DEPARTMENT OF THE ARMY TECHNICAL BULLETIN

REWORK OF AIRBORNE LASER TRACKER
 INSTALLATION
 AH-1F HELICOPTERS

Headquarters, Department of the Army, Washington, D.C.
 31 December 1991

TB 1-1520-236-30-2

Figure 1. Side View of Airborne Laser Tracker Installation.

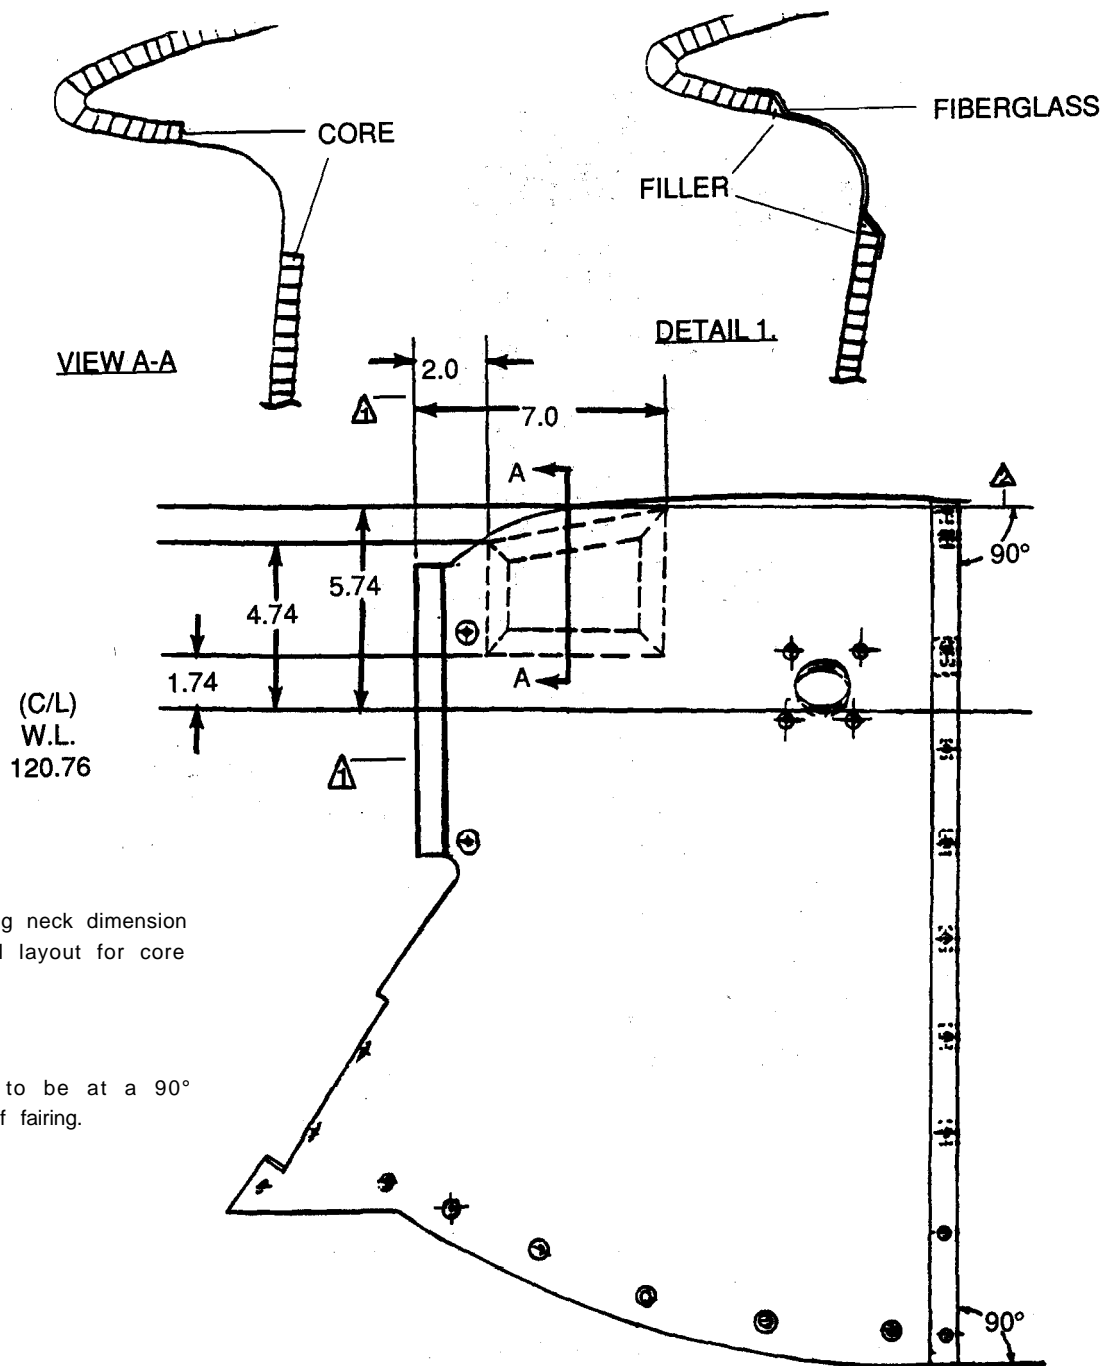
- d. Remove seal P/N 110-004-13-0269 from the I.D. of Airborne Laser Tracker opening in Forward Pylon Fairing to allow for additional clearance. See Figure 1. Removal of the seal allows for additional clearance between the Fairing and Optical Dome without any degradation to the installation. If clearance is obtained go to page 8, para 11.e.(2)(d), if not continue with next step.

NOTE 1:
Remove seal P/N 110-004-13-0269 from Fairing to allow for additional clearance.

NOTE 2:
Inspect for contact between Airborne Laser Tracker Dome and Fairing in this area. No contact is allowed.

NOTE 3:
After modification check for contact between receiver mount bolts and fairing

Figure 3. Rework/Modification of Forward Fairing.

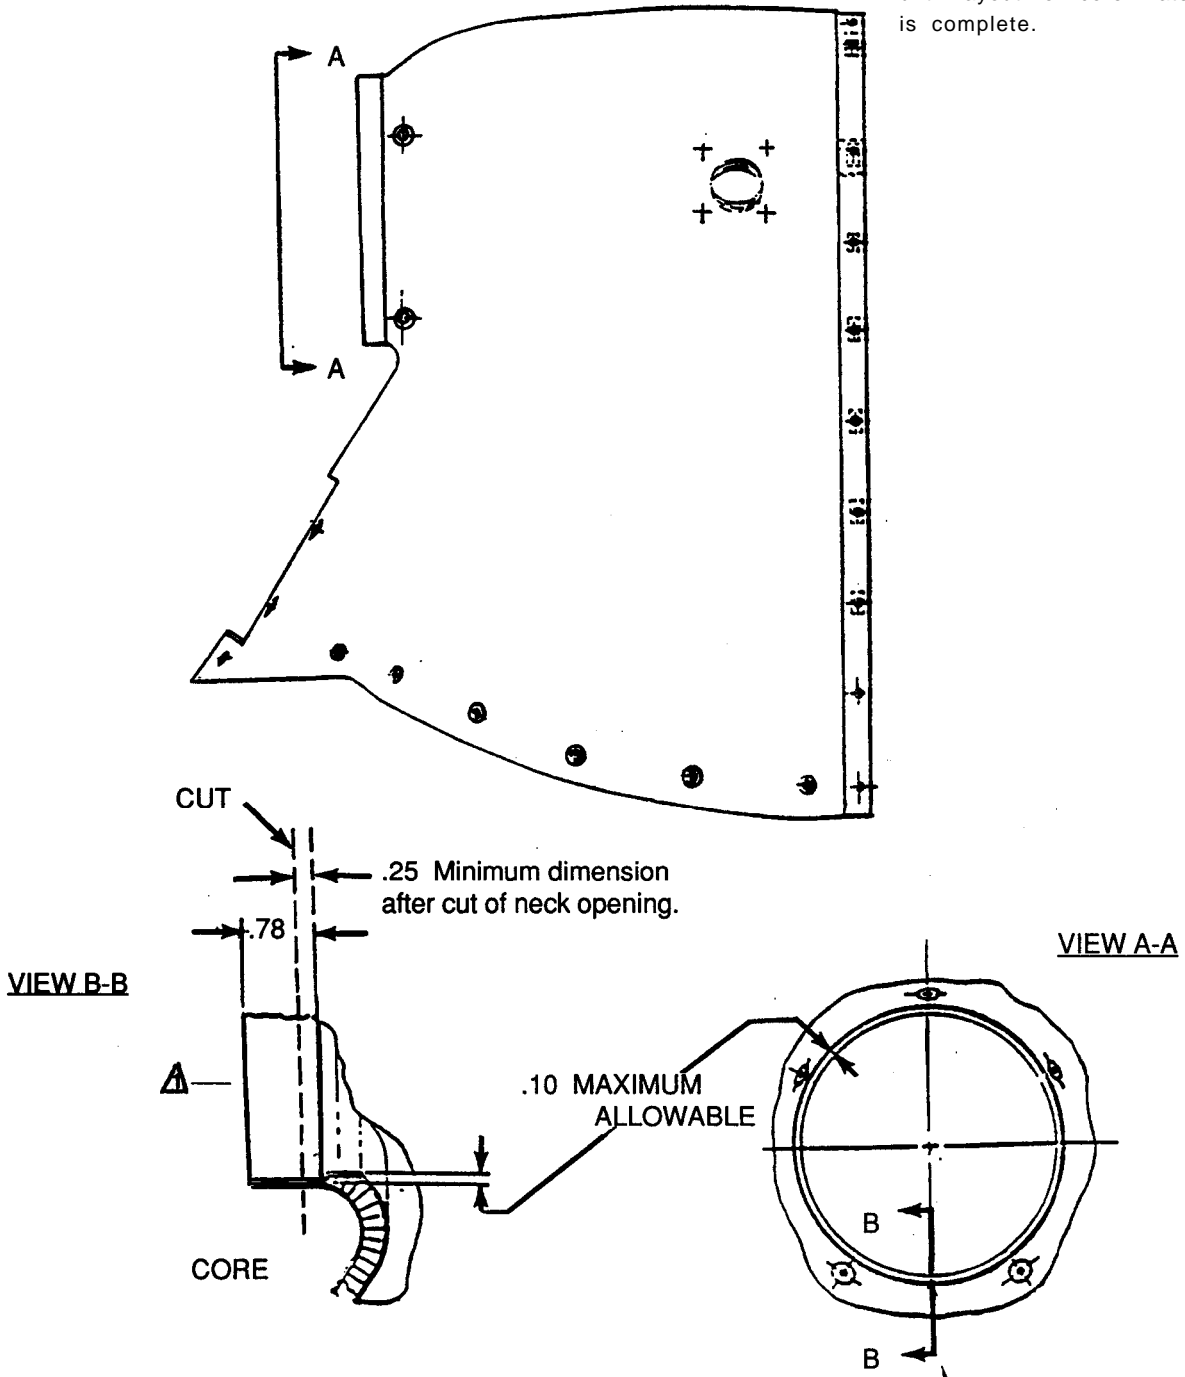
- e. Perform rework/modification on Forward Pylon Fairing in accordance with Figures 2 and 3.
 - (1) Remove core material from inside of fairing in accordance with Figures 2 and 3.

- (a) Mark areas that core will be removed from on top layer of inner skin surface of fairing.
 - (b) Use rotary files and utility knife as required to remove top layer of skin and core material. Caution should be used when removing core material to not penetrate thru the outer skin of the fairing. Reduce neck opening in accordance with Figure 3.

- (c) Remove debris from area and clean with alcohol.
 - (d) Mix an adequate amount of 1310 filler material to form a 45 degree chamfer around the exposed core material. See Figure 2. Allow to dry.

Do not reduce opening neck dimension from .78 to .25 until layout for core material is complete.

All dimensions are to be at a 90° angle from aft edge of fairing.

NOTE 1:
Do not reduce opening neck dimension from .78 to .25 until layout for core material is complete.

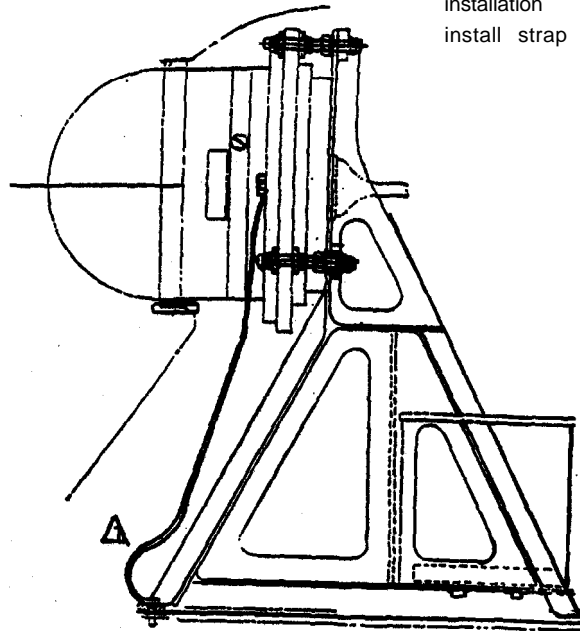
If braided strap (P/NSM-D-968532-2) is used from Airborne Laser Tracker installation kit (P/NSM-A-96853) then install strap as shown in Figure 4.

Figure 4. Shimming of Airborne Laser Tracker Support.

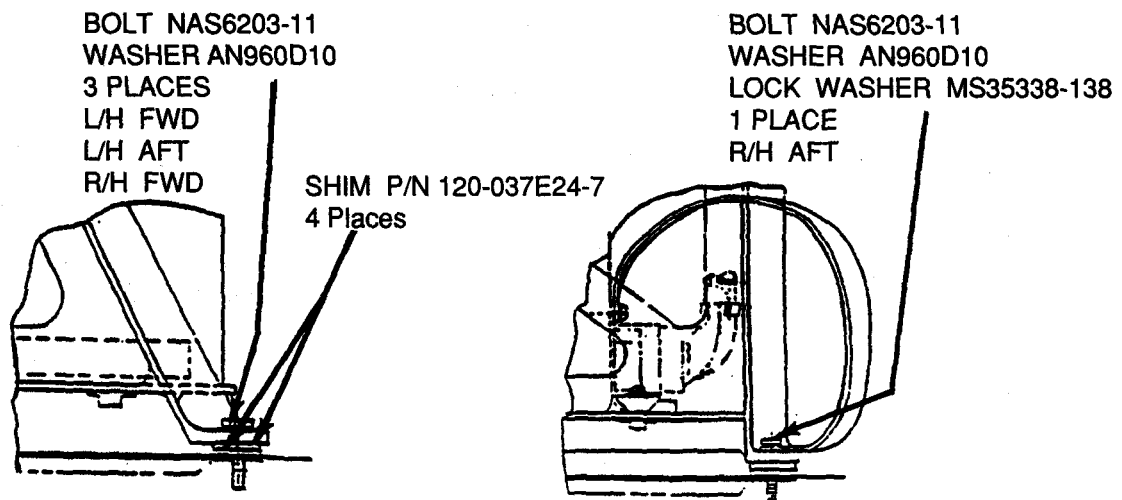
(2) Install Receiver Support Assembly with the approximate amount of shims required in equal amounts under each of the four mounting points. Maximum allowable shim under mounting points is 0.188 inch or 2 ea. 120-037E24-7 shims. Retain Receiver Support Assembly with bolts, P/N NAS 6203-11. See Figure 4.

Shim Equally at Four Mounting Points.

Figure 5. Electrical Bonding.

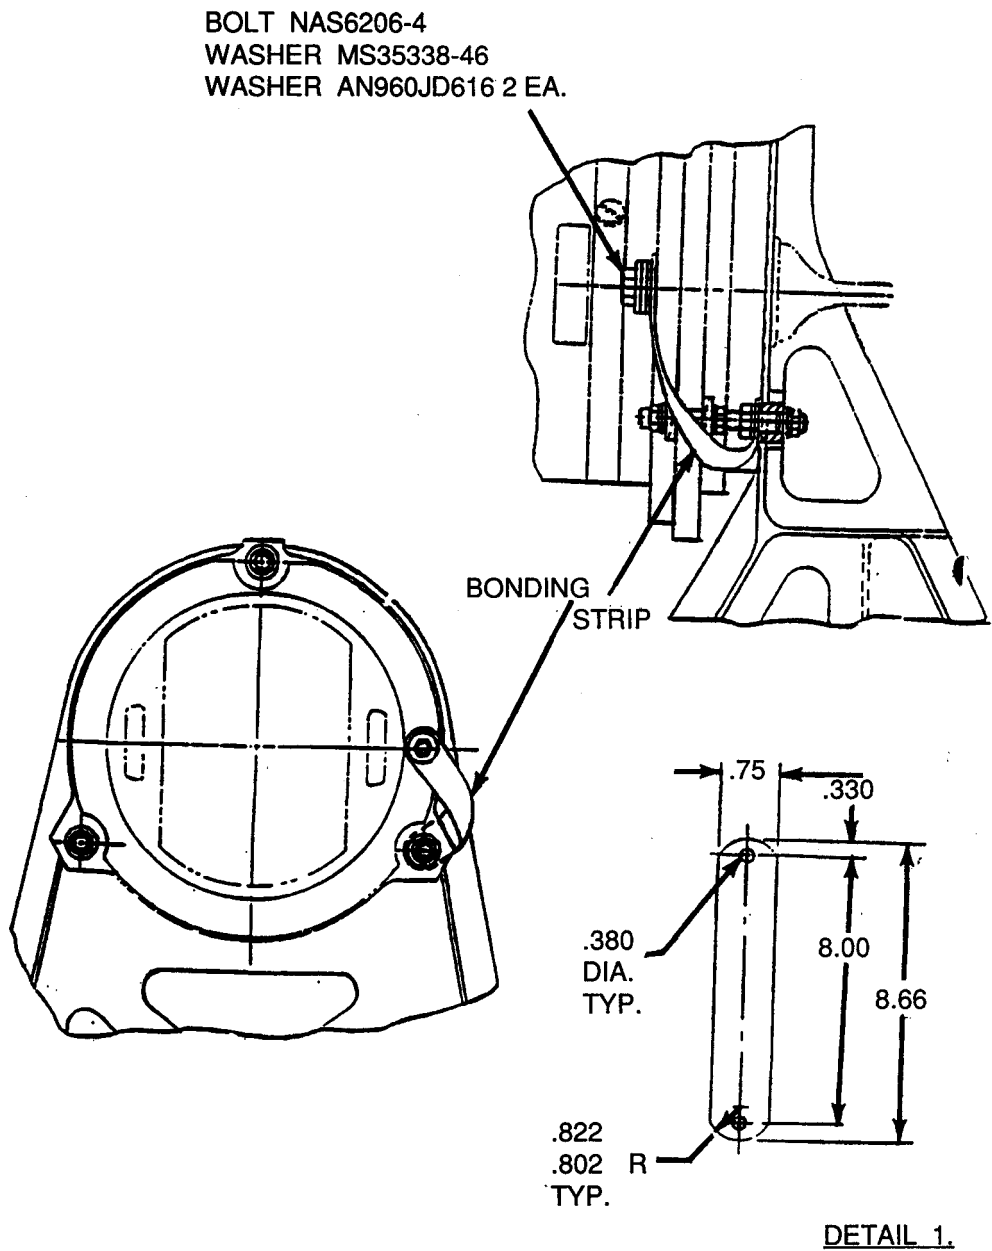
(1) If BHTI Bonding Strip, P/N 120-175-EE08 is not available, then locally manufacture a bonding strip from 6061-T4 Aluminum Alloy per QQ-A-250/11 with Chem Film per MIL-C-5541 Class 3 in accordance with Figure 5.

(2) Install Bonding Strip in accordance with Figure 5.
